Amendments to the Drawings

Attachment: Replacement Sheet

FIG. 1

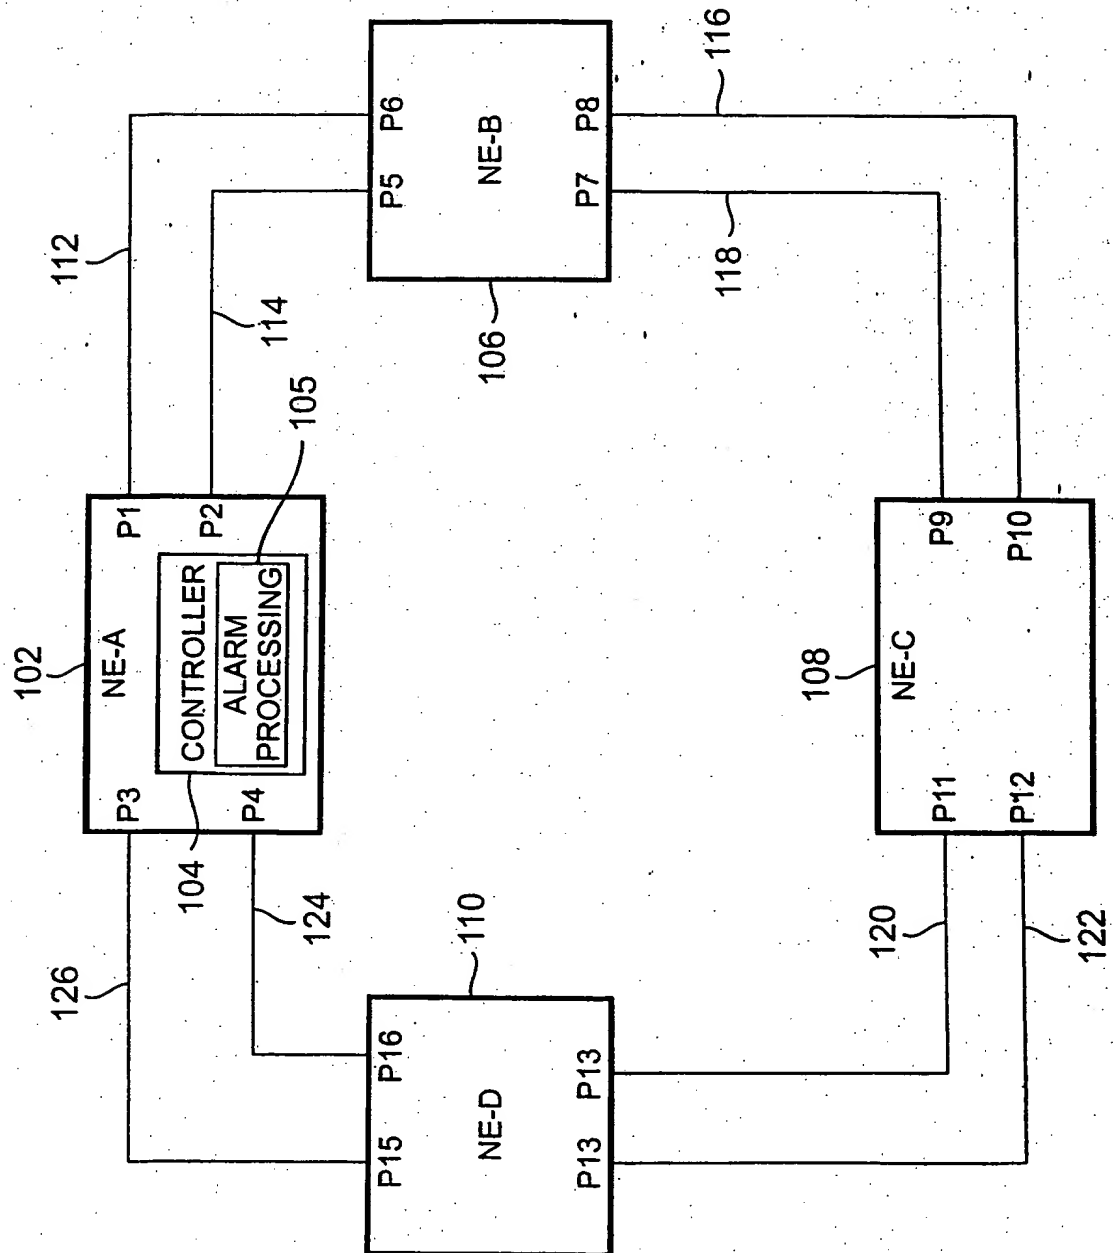
In Figure 1, a block depicting the alarm processing of the present invention, a descriptive label for the added block, and a reference number for the alarm processing block have been added.
